Design Exception #5 Slopes at the MP 185 Cut Wall

I-70 West Vail Pass Safety and Operations Improvements

Issue Task Force Design Exceptions Meeting #5
August 23, 2021

Project Leadership Team Meeting #10 November 12, 2021

Cut Walls at MP 185: Overview

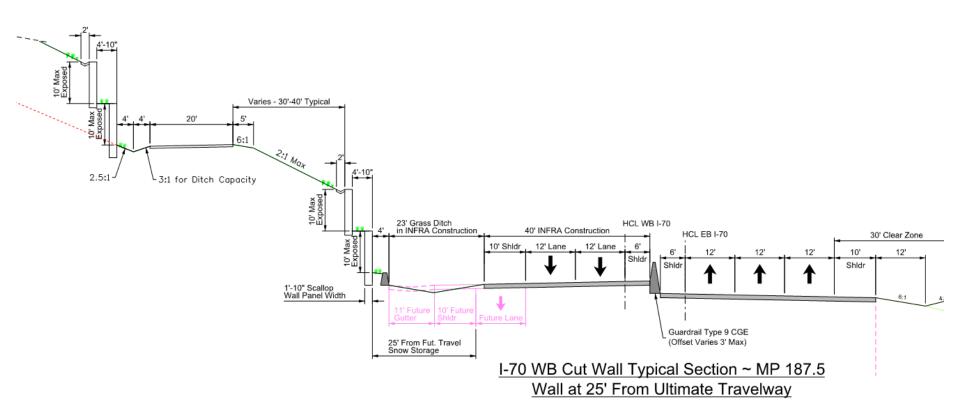
- Dick said he went out to look at where the US 6 highway would be relocated. From a laymen's perspective, it looked like the trail at MP 185 is on a very steep hillside and it would be significant to cut that corner. Have you looked at that yet or have sufficient topos to do that at this point?

Greg said I know when we were talking about the roadway design and the bridges, you said the bridges were about 10 feet apart or parallel and then there was a space when you go to your section, it does not look like we have any kind of median.

- through this section. This will be updated to show further separation as there is actually 8 to 9 feet in there.
- Greg asked for clarification that the Design Exception is a grading exception, not a wall exception.

Brian said we can't get the trail high enough to overcome all the grade. We are widening into an existing steep slope so pushing it out helps gain some of that grade and it's a pretty straight-line grade. I'm sure we didn't get over 10% in trying to optimize that profile.

Brian said it is shown incorrectly. On the westbound side we have the 6-foot inside shoulder and there will be a little bit more of an offset. We are working through the details of whether we need to have barrier on eastbound and westbound individually or whether we can have that CD barrier in the middle. There will be just a little bit of an open median

- Brian confirmed a grading exception is what we are requesting. To reduce the walls, we would like to use the 2:1 slopes grading design exception.
- b) Mary Jo noted the range we chose is not exact. The slopes look better when they undulate. We are looking for a slope range that would give the designers flexibility. The design exception we are recommending is:

- Use slopes ranging from 2.5:1 to 1.8:1 as directed by the project Landscape Architect to create a slope that fits into the adjacent landform, looks natural, sustains vegetation and is maintainable.
